U.S. Department of the Interior
BUREAU OF LAND MANAGEMENT

Notice of Intent

Type of Action: Plug and Abandonment

Plug and Abandonment Procedure
for
DJR Operating, LLC
Carson Unit Coal 17 # 1
API # 30-045-31966
NW/SW, Unit L, Sec. 17, T25N, R11W
San Juan County, NM

**DJR Operating, LLC
Proposed Wellbore Diagram**

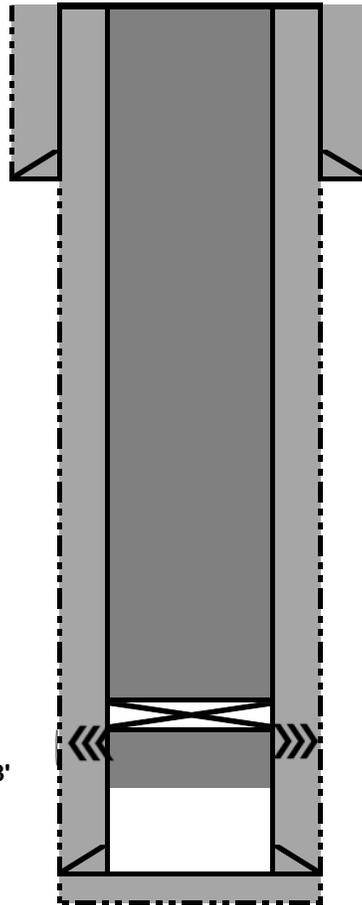
- BLM formation top picks for the Kirtland, Fruitland and Ojo Alamo formations vary from operator picks. No change to the P&A procedure is required (entire well bore will be cemented to surface).
- Log analysis of reference well #2 indicates the Nacimiento and Ojo Alamo sands investigated likely contain fresh water ($\leq 5,000$ ppm TDS). P&A procedure has cement from the cement retainer @ 1150' to Surface which will protect freshwater sands in this well bore.
- Fruitland Coal perforations @ 1176'-1228'.
